Detailed Site Plan 9395 Lanham Dunkin

DSP-23034

REQUEST	STAFF RECOMMENDATION
Development of an approximately 2,427-square-foot eating and drinking establishment with drive-through service.	APPROVAL with conditions

SUBJECT: Detailed Site Plan DSP-23034
9395 Lanham Dunkin

Figure 3: Proposed Detailed Site Plan

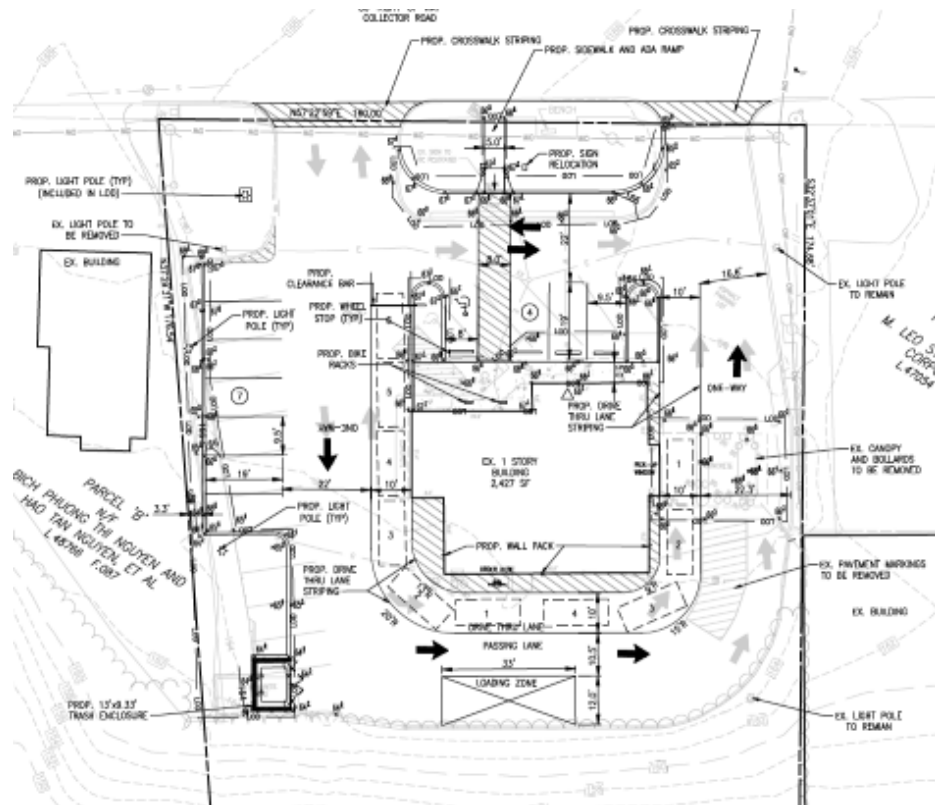
1. Prior to certification of the detailed site plan (DSP), the following revisions shall be made, or information should be provided:
 - a. Revise General Note 1 to include the plat recording reference of the subject property (Plat Book WWW 32 Plat 54).
 - b. Add the following note:

“During the construction phase, the applicant shall adhere to all applicable Prince George's County or State of Maryland regulations and laws regarding particulate matter, pollution, and noise.”
 - c. Provide seating and trash receptacles within the property's frontage.
 - d. Revise Sheet 3 to include the height of the existing building.
 - e. Revise the front elevations on Sheet 5 and Sheet 7 to be consistent.
 - f. Label the width of the provided street connections.
